**To:** Brad Sedgwick  
**From:** Pat O’Mahony, Associate Planner; 910-341-0189  
**CC:** File;  
**Date:** 11/12/2020  
**Re:** Nourish NC TRC Rev. 2

Departure Sight Triangles (Stop-Controlled)

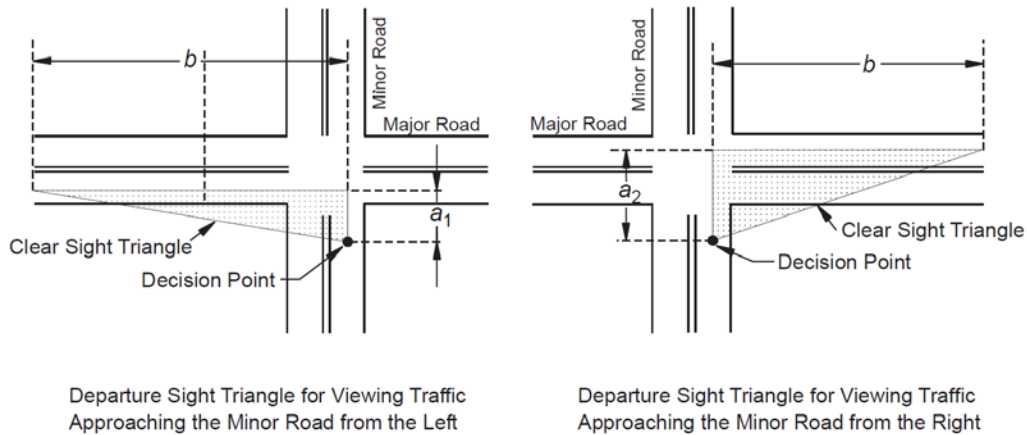
**SIGHT DISTANCE TRIANGLE FOR ANY STREET/DRIVEWAY INTERSECTIONS WITH THOROUGHFARES**

Market St is a major thoroughfare [Chap VII (C) (2) (a) of CofW Tech Stds]. In accordance with the City Code, sight distances along thoroughfares must be calculated in compliance with the AASHTO requirements. [Chap VII (C) (1) of CofW Tech Stds] [Sec.18-556 CofW LDC].

Show the departure sight distances with dimensions for the intersections on site and landscape plans.

Refer 'AASHTO A Policy on Geometric Design of Highways and Streets', Chapter 9.5.2 Departure Sight Triangles. Here minor road is driveway. Since it is an apron style driveway it is considered as a stop-controlled, regardless of stop sign.
